Subject: FW: Meeting on Council response to Frasers RTS – 75W Modification

We are currently finalising our response to DPE on the s75w modification and are reviewing the building height requirements and comments in Council's submission on building heights

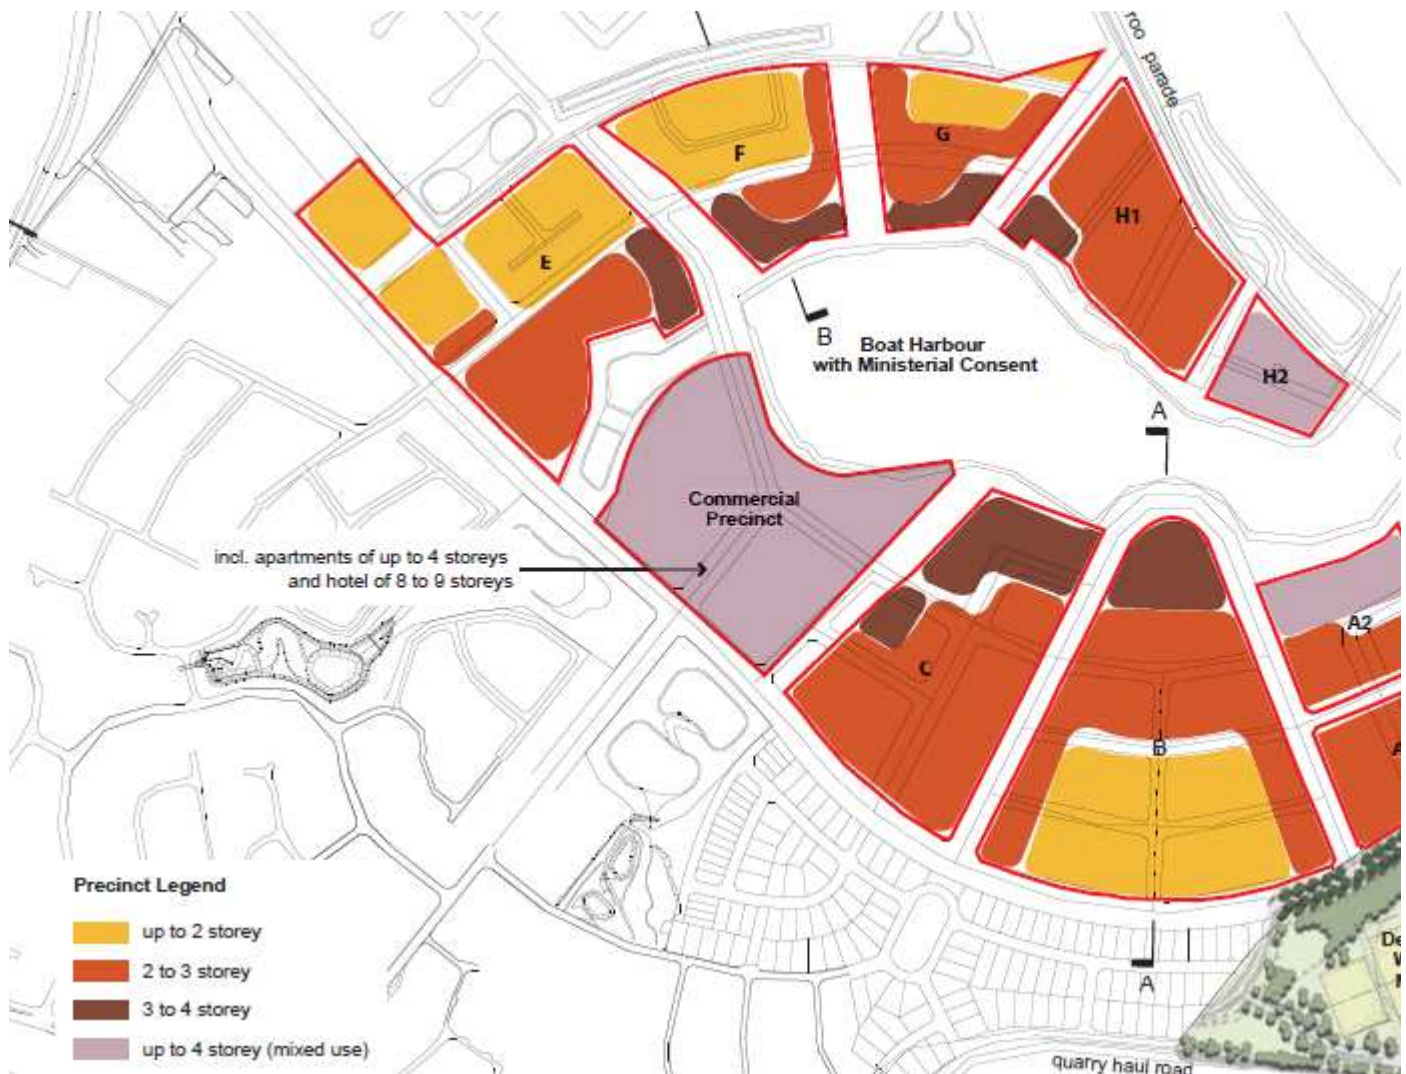
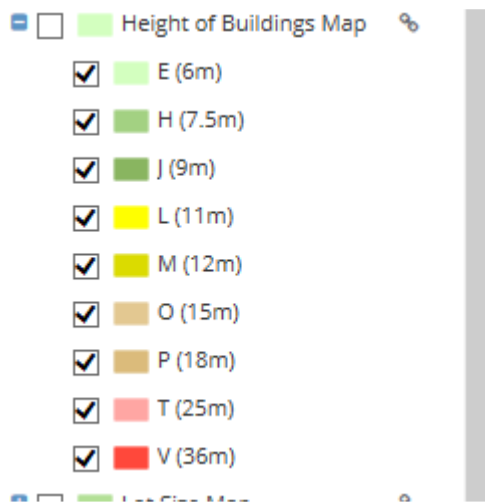
In relation to building heights for standard 2 and 3 storey buildings, we had utilised the height for this product type direct from Council's LEP. Council's current LEP interpreted the locations of 2, 3 and other building heights from the concept plan approval and converted these to building heights in metres (see below extracts from the LEP and concept plan approval. the LEP converts 3 storey dwellings to a 12m building height (see M locations below) and 2 storey buildings to a 9m height (see J locations below). Could you please confirm that this is an appropriate allowance and if there is any reason we should not adopt the heights Council has determined in the LEP?

Council's LEP height controls for the CPA were developed in the absence of any detailed design considerations, which have now been developed and contained in the Urban Design Guidelines for precincts. The physical built form is also taking shape in the CPA .

In other areas of the LGA there is a 9m height for R2 and R3 zones. This reflects the Shellharbour DCP which provides for residential to be 9m with a 7m wall (7m to allow for sloping sites) and then traditional pitched roofs – 9m.

The built 2 storey product in the CPA appears lower than 9m, owing to low pitched (close to flat roofs in some instances) and non - steep sites. Overall heights are often dictated by the wall heights of skillion roofed dwellings or walls joining gabled roof tops. Walls on the few 2 storey hipped roof dwellings built are lower than skillion/gable roofed dwellings.

Approved UDGs have maximum wall heights of 7.5m and this accounts for wall heights of skillion roofed dwellings or walls joining gabled roof tops.

The upshot is Council offers no specific direction on this matter, especially given we are not the consent authority. What is important is that a "height" definition be included in the CPA in order to measure height. The one contained in the standard instrument would be appropriate.

Any modification approval should account for the observations above, especially the wall and roof top heights inherent in different designs as constructed and as reflected in approved UDGs. Council would be amenable to reviewing height provisions in UDGs for consistency with any final modification approval.
